# **Appendix C**

Sydney Water Email

**Subject:** RE: PSD & SSR Requirement (Metro Martin Place - South and North Towers)

# South Tower

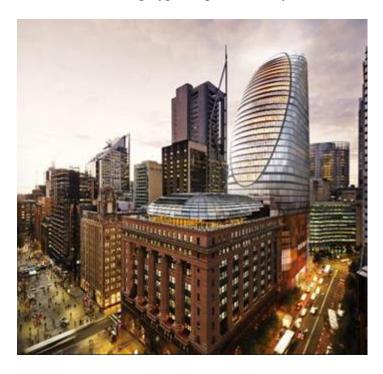
Development Address: Refer to image below

Area: 1920m2

You can use the following On Site Detention parameters for the both North and South towers:

On Site Detention
16 cubic meters for every 1000 square meters of site area

Permissible Site Discharge
36 L/s for every 1000 square meters of site area
